DRAINAGE LETTER REPORT

**WOODFORD MANUFACTURING BUILDING ADDITION
LOT 1, BLOCK 1, WAYNOKA ROAD INDUSTRIAL
2121 WAYNOKA ROAD, COLORADO SPRINGS, CO**

**JPS Project No. 051801
PPR-18-037**

DEVELOPED DRAINAGE PLAN

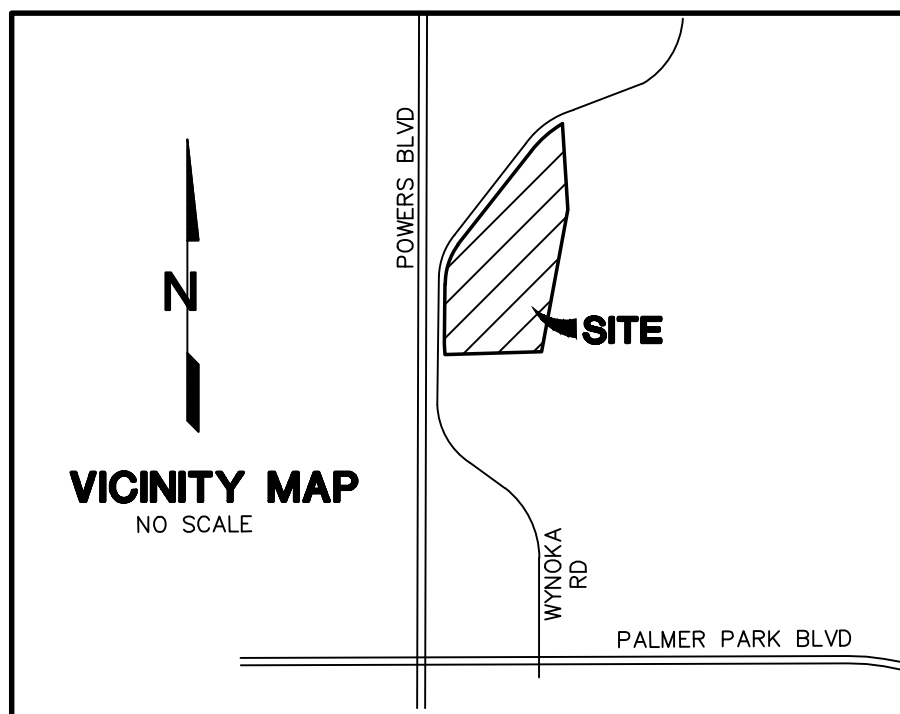
Per discussion, suitable outfall analysis shall include the inlet downstream.

Provide a narrative for this basin.

Identify the Q drained through the swale from the existing downspout. The roof area tributary to the downspout must be accounted for in the WQ BMP design.

Was this ex inlet sufficiently sized for the 100yr or does pass-by flow occur? Update the narrative and calculations accordingly.
